Moolarben Stage 1 MOD 15

Further Information on the impact on the groundwater system from UG4 mine

Figure 1: Location of MCC UG1 & UG2; monitoring bores PZ192,, PZ193, PZ105, PZ103, PZ191 & PZ179 and proposed location of dewatering bore sites (MOD 15)

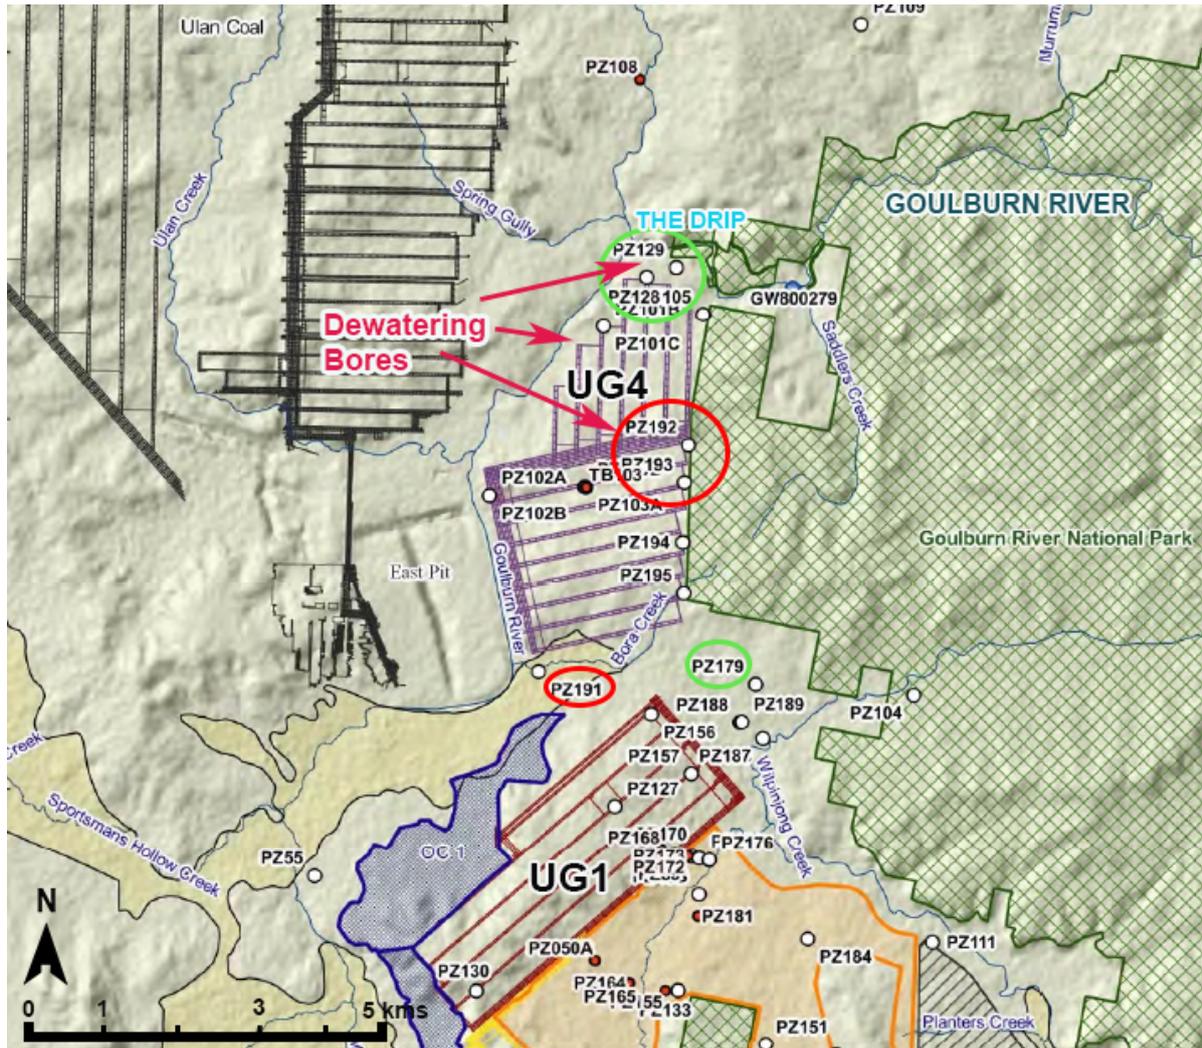
The location of the northern bore sites - opposite The Drip GDE¹, and approximately 250 metres from the Goulburn River is of major concern considering the close proximity to significant natural features, cultural sites and the potential interception and depressurisation of the Triassic/upper Permian groundwater system. Construction of the northern dewatering sites is predicted to occur about the year 2026.

There has been a more than 6 fold increase in actual mine water-make (1 ML/day to > 6.8 ML/day) compared to the earlier predictions of groundwater inflows (Middlemis and Fulton, 2011) (HydroSimulations, 2017). The source of this extra inflows has not been adequately investigated but is most likely to have been due to interception of additional groundwater sources above the coal seam - from Triassic and upper Permian water bearing strata. Groundwater monitoring since 2016 show a significant decline in standing water levels in all water bearing strata at a number of monitoring bores 2-4 kms from UG1 (Figure 1 - PZ179, PZ191, PZ192 and PZ193).

MCC has frequently reported that the quality of groundwater within the UG4 footprint is low quality and of limited value. The salinity and pH of groundwater monitored at PZ103 and PZ105 (located within the UG4) demonstrates the presence of high quality, potable water sources in all three water bearing strata - the median range of salinity EC levels 235 - 580 $\mu\text{S}/\text{cm}$, with a potential yield in excess of 4 litre per second (Table 1). The characteristics of these groundwater sources should trigger the Aquifer Interference Policy (NSW Office Of Water, 2012). There is also evidence based on hydrochemical characteristics and behaviour of the SWLs in response to mining that there is connectivity between the water bearing strata. A possible explanation for the high quality potable groundwater in the east could be the result

The MOD 15 expanded groundwater dewatering bores should not be approved.
